| Flight Procedures Cover Page        | Task Action:<br>FLIGHT CHECK | Task Type:<br>SID                             | Estimated Chart Date:<br>05/14/2026 | APWS Task ID:<br>51A599C3B400473DAD997DA024012BA1 | APWS Project ID:<br>399BFA1B90024DEE800DD40913449C04 |
| Procedure:<br>MIAMI THREE DEPARTURE |                              | Enroute:<br>YES                               | Specialist:<br>Sweeting, Dexter     |                                                   | Agreement Number:                                    |
| Airport ID:<br>KMIA                 |                              |                                               | Airport City:<br>MIAMI              |                                                   | State:<br>FL                                         |

MIAMI, FL: MIA  
MIAMI DEPARTURE

MIAMI TWO DEPARTURE  
(MIA2.MIA) 26DEC24

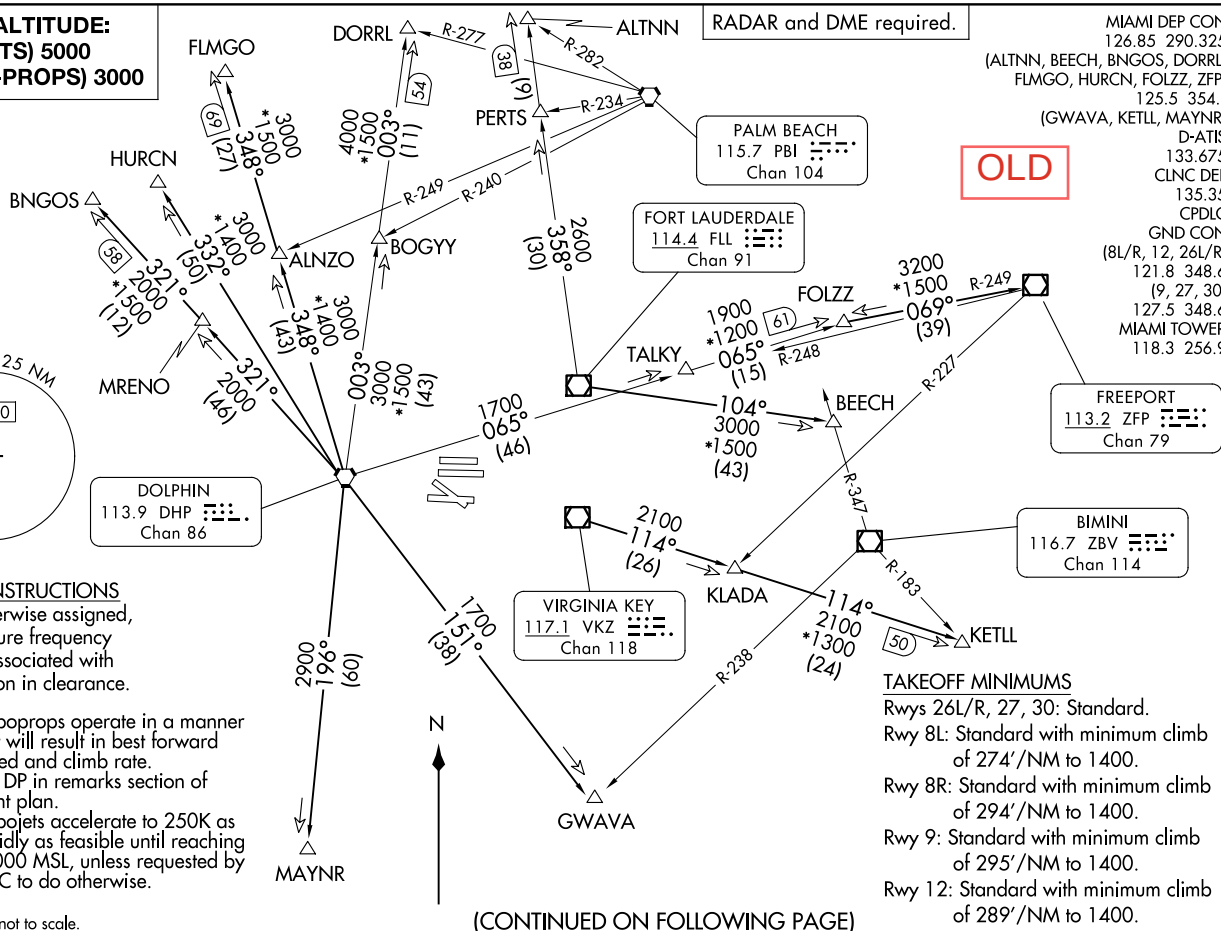
NOTES: REMOVED NOTE TURBOPROPS OPERATE IN A MANNER THAT WILL RESULT IN BEST FORWARD SPEED AND CLIMB RATE.

NOTES: CHANGED MIAMI INTL NOTE FROM "TURBOJETS ACCELERATE TO 250 KIAS AS RAPIDLY AS FEASIBLE UNTIL REACHING 10,000 MSL, UNLESS REQUESTED BY ATC TO DO OTHERWISE" TO "ACCELERATE TO 250 K UNTIL LEAVING 10000, IF UNABLE, ADVISE ATC."

REMARKS: ADDED "LOWEST ALTITUDE ATC WILL ASSIGN FOR X51, TMB, OPF, TNT, HWO IS 2000 MSL. ATC WILL NOT DEVIATE FROM TH MIA DRD ALTITUDES"; REMOVED "ABBREVIATED AMENDMENT."
